**APPENDIX 4B**

**DETAILED DRAWINGS FOR THE 200 AREA EFFLUENT TREATMENT FACILITY  
CONTAINER STORAGE AREA AND TANK SYSTEMS**

1. ECN 647892

ECN 647892, PG 14 of 27  
H-2-89040, SH 1

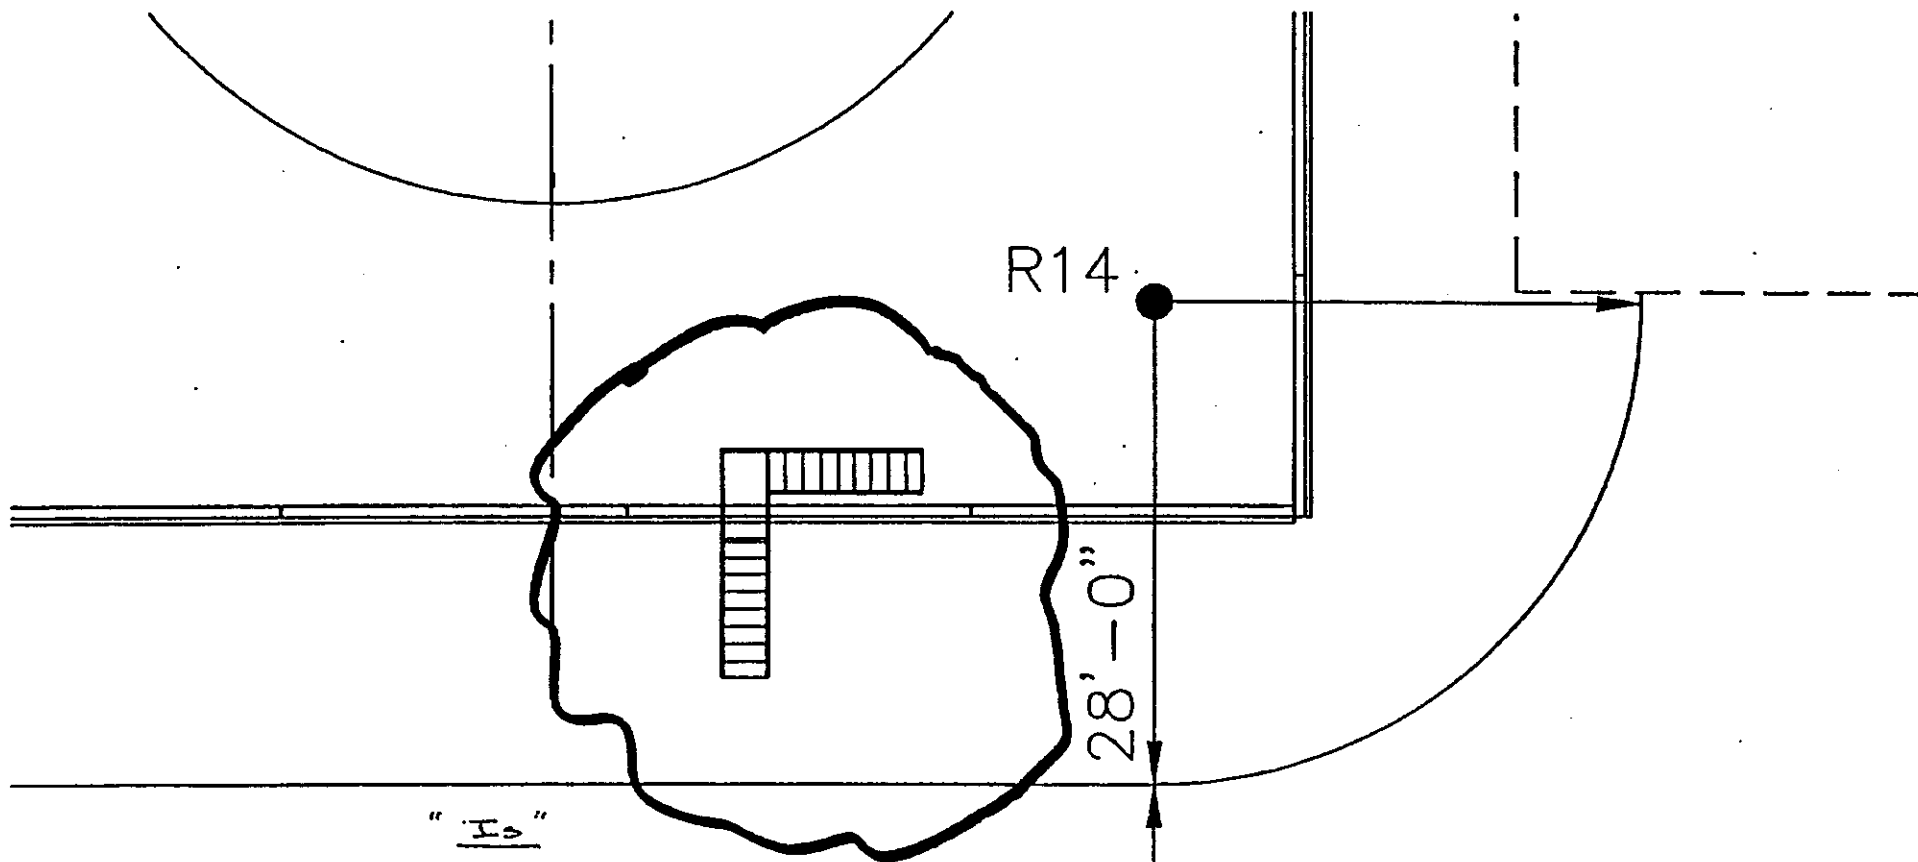
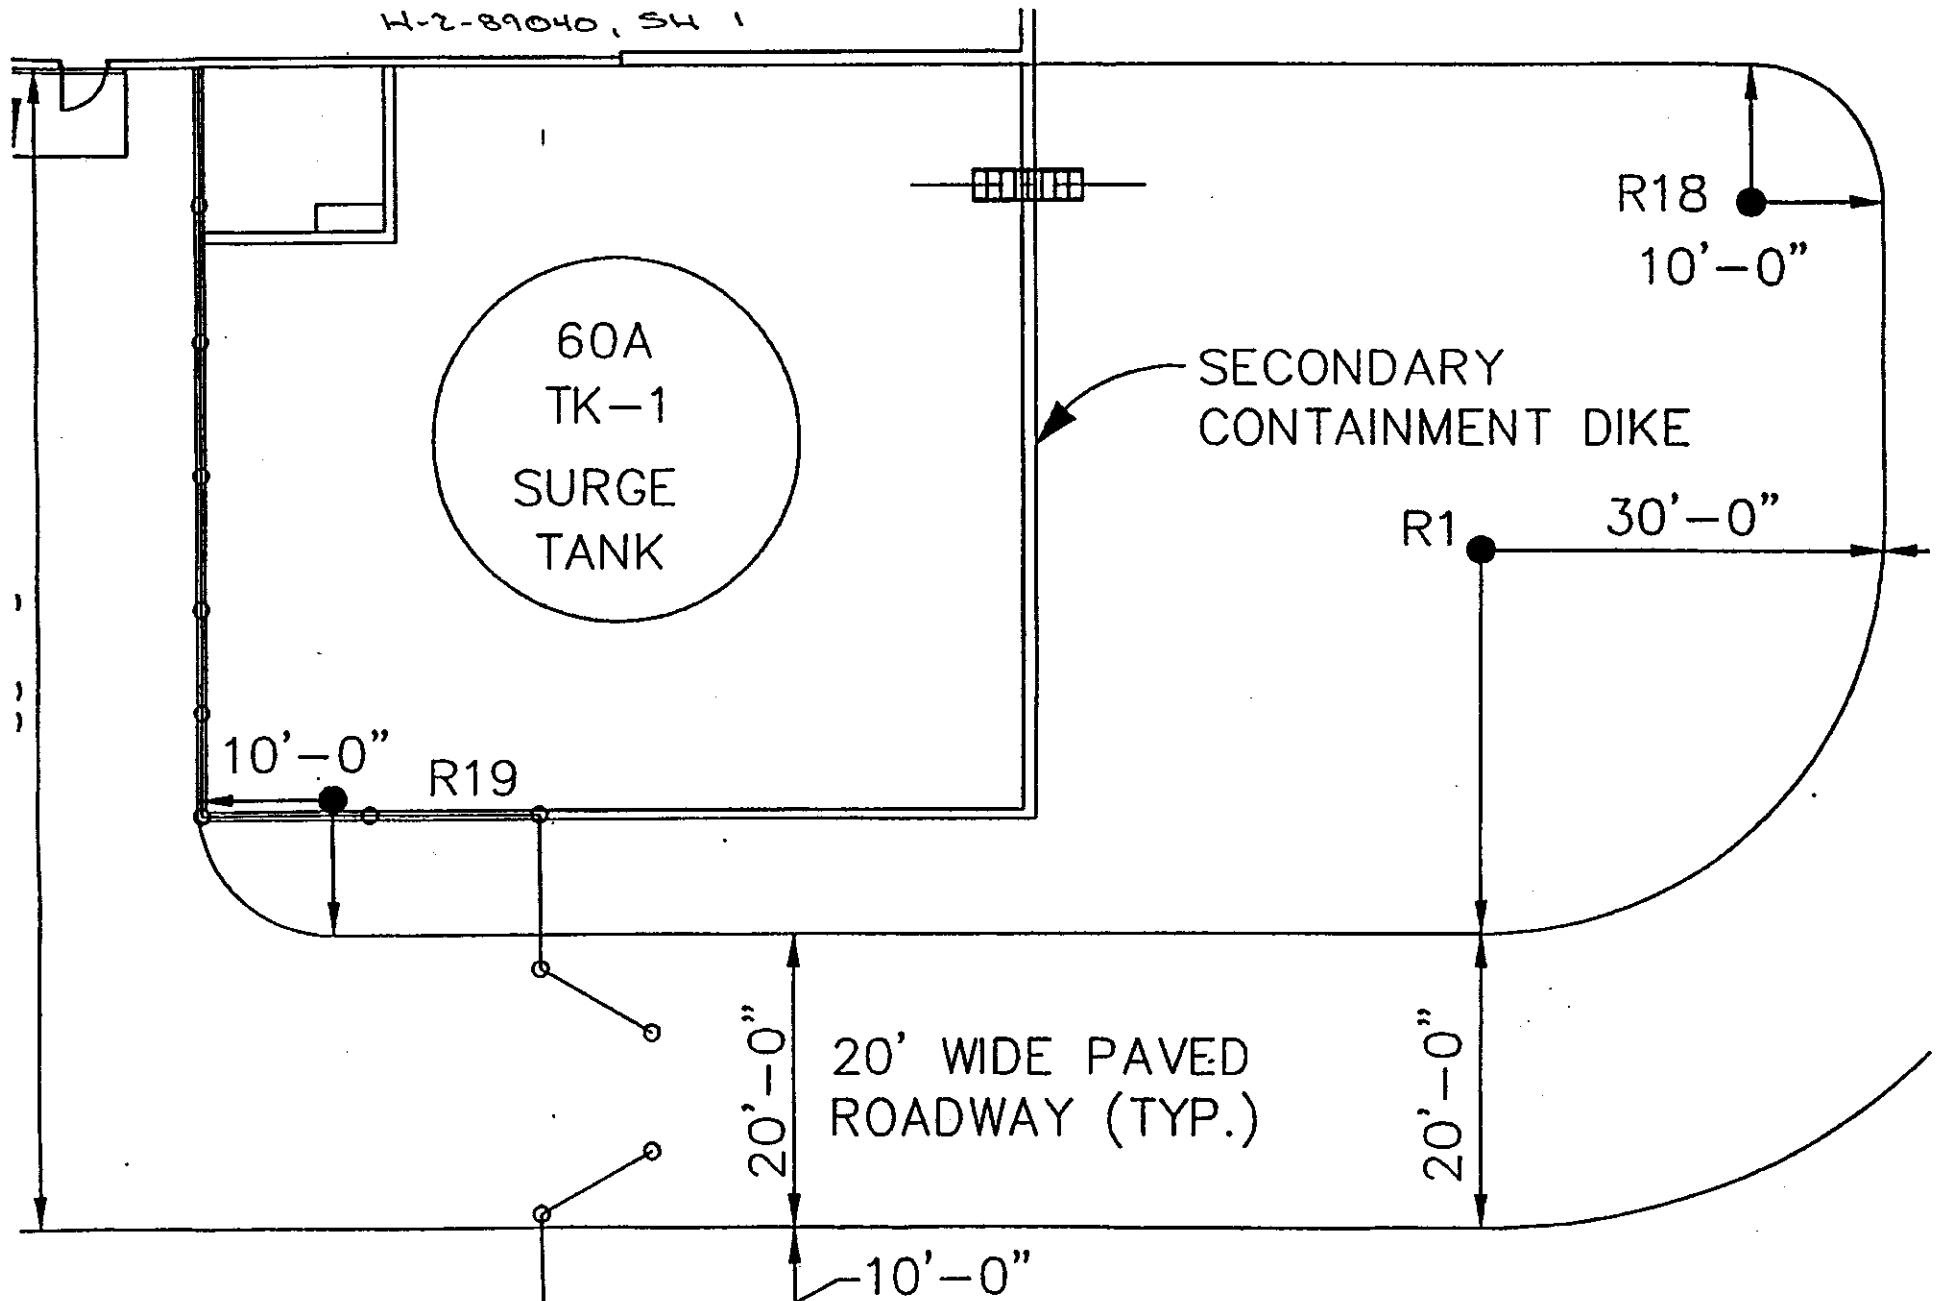
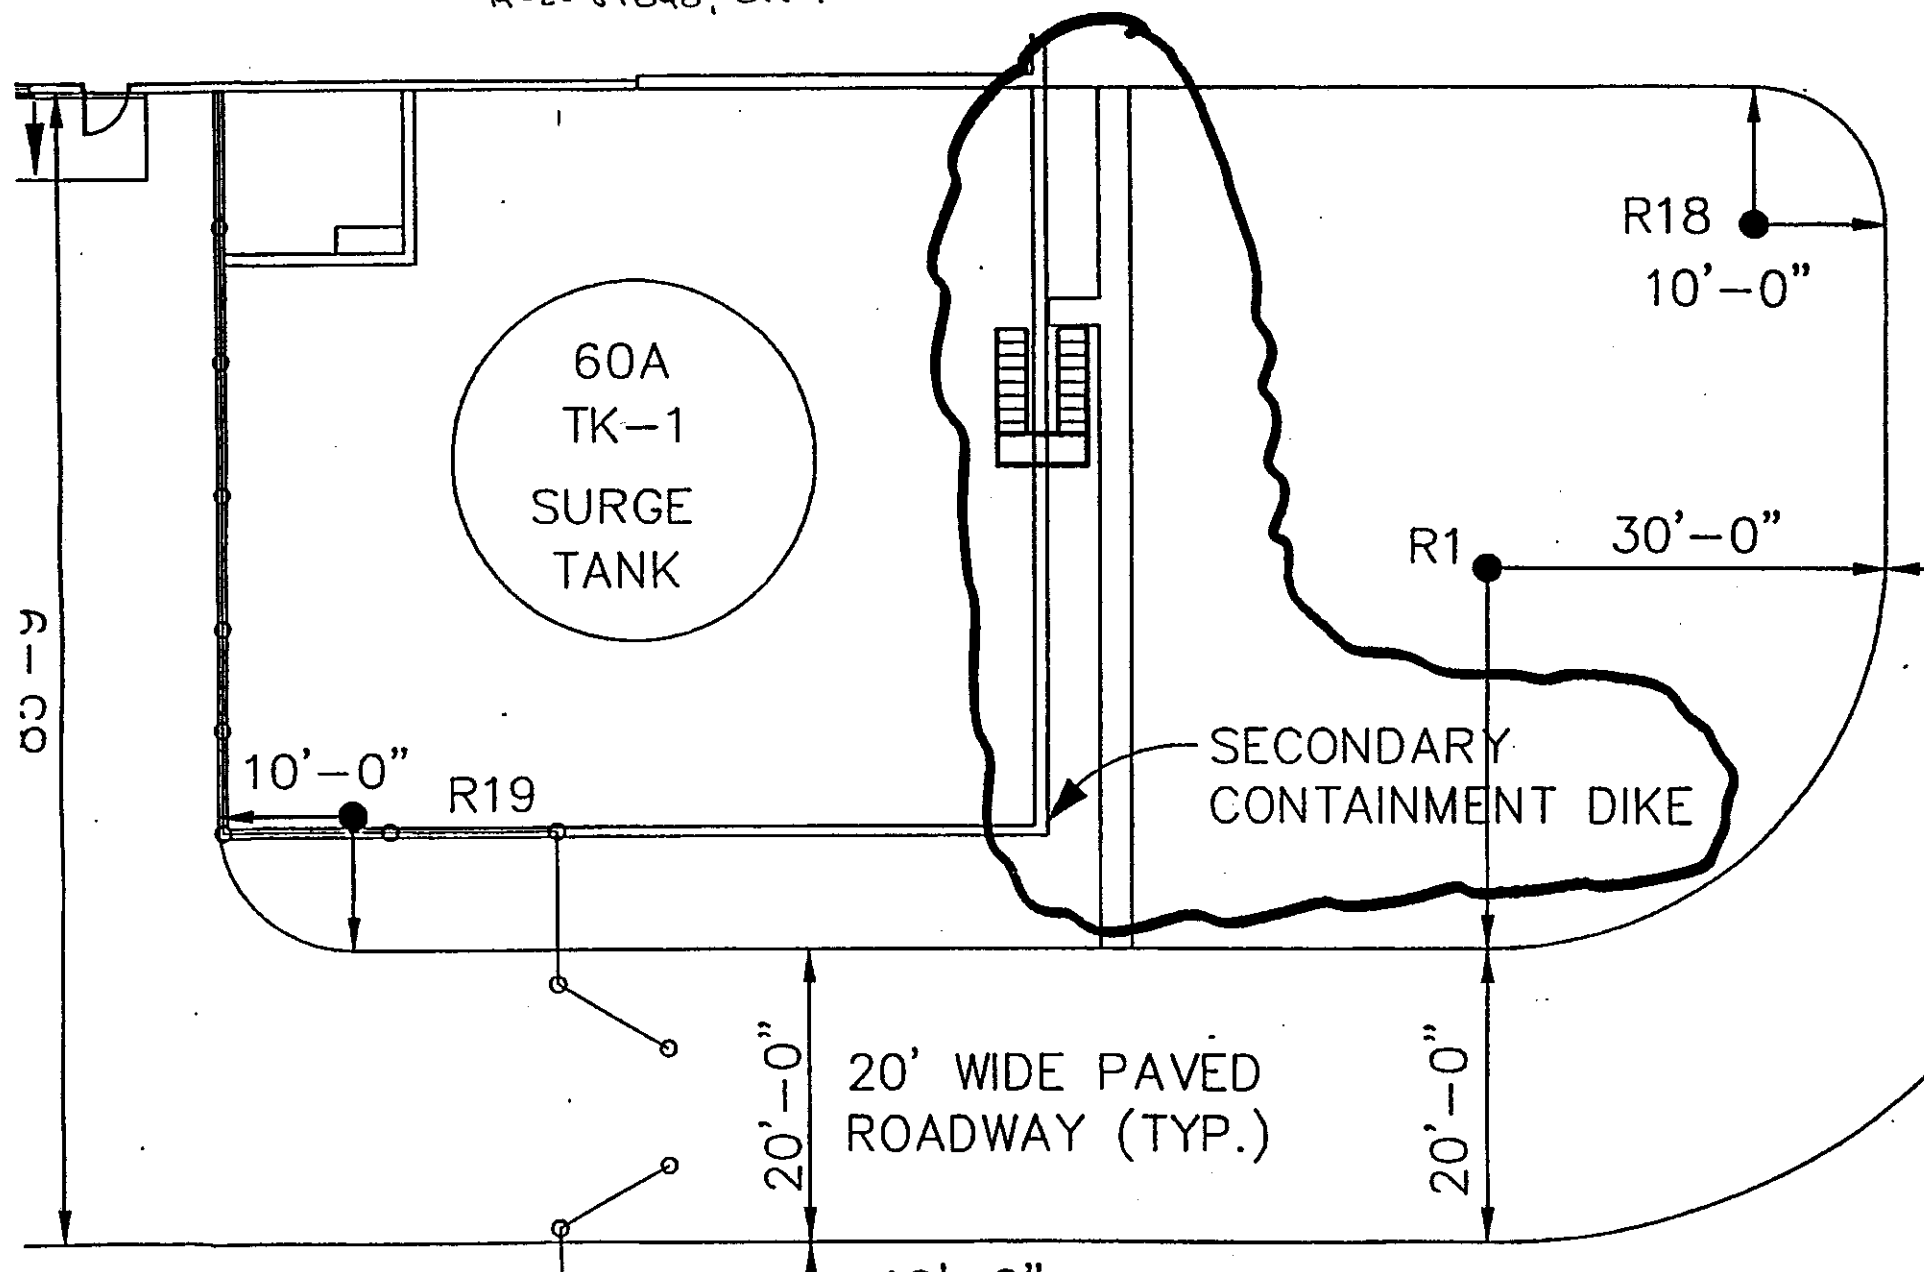
- H-2-89040, Sh 1, Zone B-4: Replace ladder with stairway & show new sidewalk.  
Zone E-4: Replace ladder with stairway.
- H-2-89044, Sh 1, Zone B-4: Replace ladder with stairway & show new sidewalk.  
Zone E-4: Replace ladder with stairway.
